Forest
Service

Allegheny National Forest
Bradford Ranger District

Date: June 8, 2007

The Forest Service, surface landowner of the Allegheny National Forest (ANF) in northwest Pennsylvania, files this official objection to the well permit applications submitted by Duhring Resource Company in a revised proposal package on May 26, 2007. The objection is for four (4) wells located in Sheffield Township, Warren County, Pennsylvania on Warrant 2445. This objection pertains to Title 58, Section 601.205 of the Pennsylvania Oil and Gas Act, "Well Location Restrictions."

Well Site 7-22

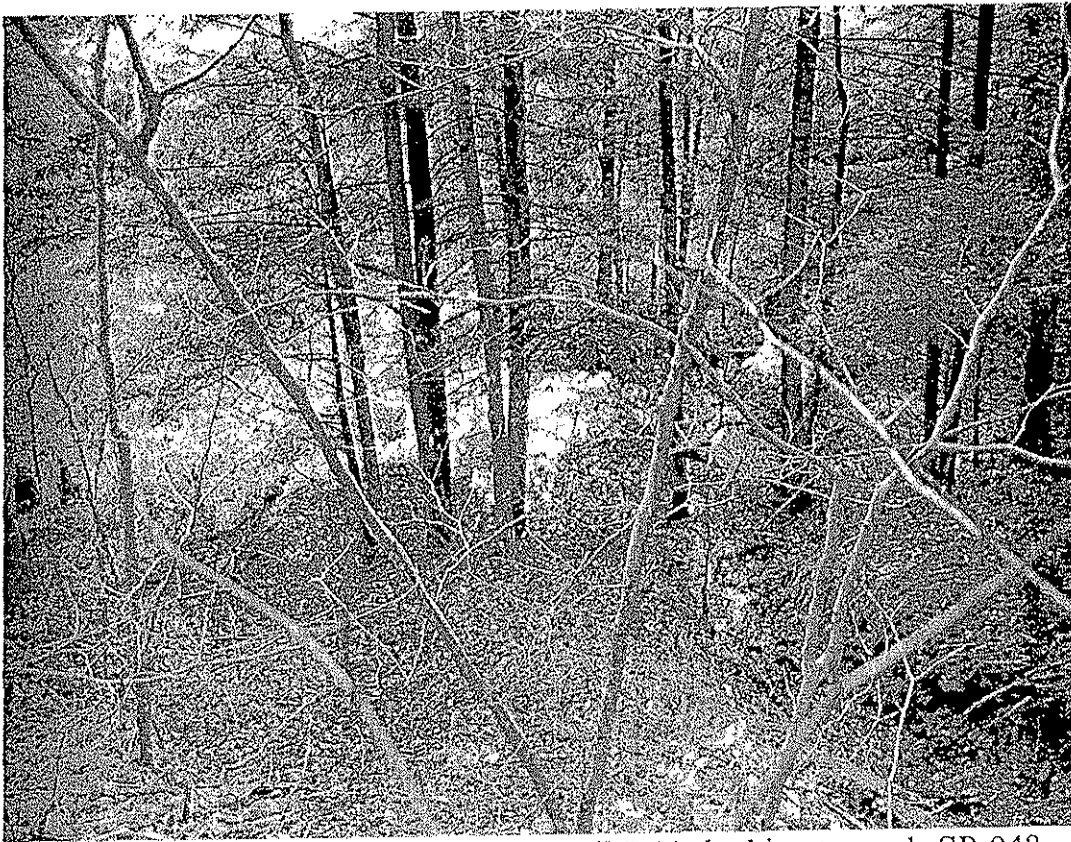
The wells in objection in Warrant 2752, Lot 7, are numbered 7-18, 7-20, 7-21, and 7-22. The Well (Farm) name is Lot 7 and is located within the Sheffield and Ludlow Quadrangles. The well plats for the objected wells were submitted to the Bradford District Office on March 20, 2007. As proposed, Well 7-18 and the access road would directly impact the North Country National Scenic Trail (NCNST) as administrated by the National Park Service. The NCNST was federally designated as a National Scenic Trail in 1980 under Public Law 90-543. Wells 7-20 and 7-21 are proposed within large spring seeps (wetlands) that drain directly into a wetland west of SR 948. Well 7-22 is proposed within this wetland. Please see the attached pictures.
